CLIENT: A59 KEX GILL DIVERSION

TITLE: Soft Landscape: Planting Plan (Sheet 7 of 15)

SCALE @ A1: 1:500	CHECKED: SF	APPROVED: AW
PROJECT NO: 70049554	DESIGNED: SF	DATE: 21/08/2023
DRAWING NO: NYKGGD-WSP-ELS-SG-DR-LE-00017	REV: C03

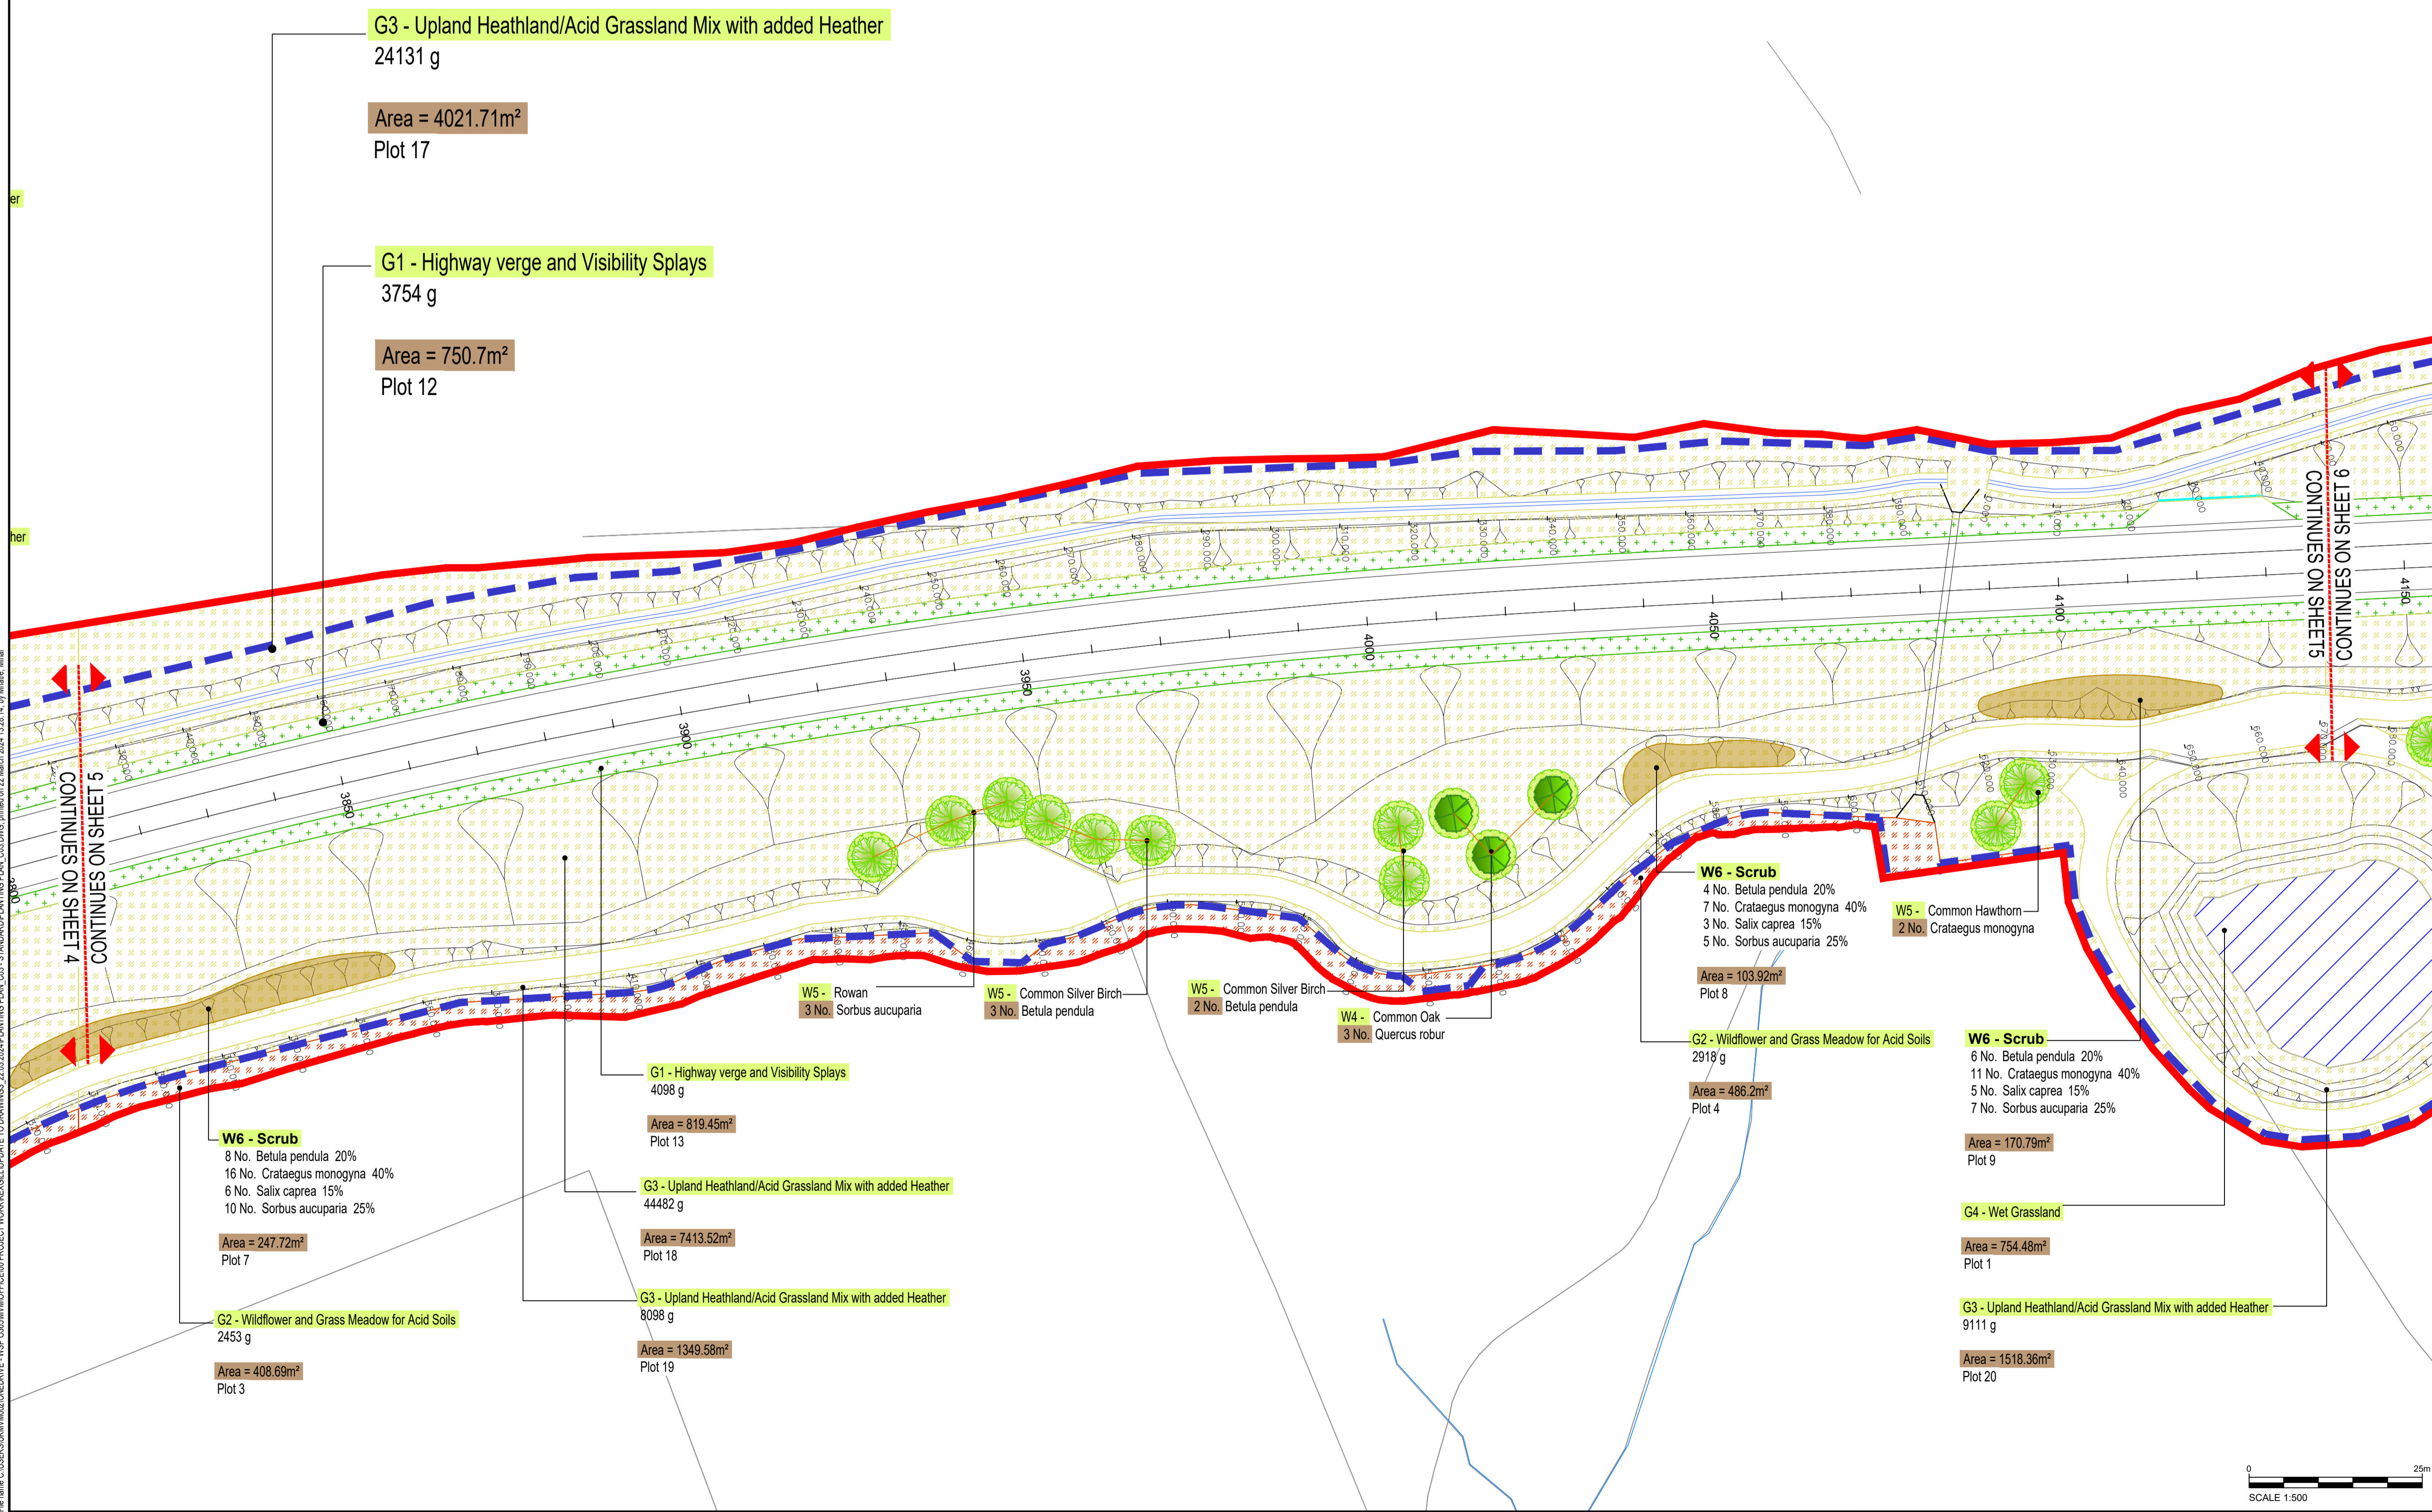
- Amendments to the design at Church Hill (minor amendments to the boundary treatments to allow for the road reconfiguration, and gates altered at church car park);

- Amendments to the design at Hall Lane (minor amendments to the boundary treatments to allow for the road reconfiguration);
- Diversion of Hall Beck (alteration to watercourse alignment and design);

- Soft landscaping around drainage areas including Attenuation Ponds (refer to Point 6);
- Siting of interceptor channels and filter drains (soft landscaping around changes in Point 3);

- Variation in slope angle on certain sections (change in type of planting in certain areas due to underlying geotechnical feature placement associated with soil stability);

- Inclusion of reinstatement works for areas used as temporary construction compounds;
- Areas of woodland and scrub planting are to be reconfigured, following recent tree clearances; and

- No. 8 additional tree guards will be provided within livestock fields near Blubberhouses Hall to protect growing trees.
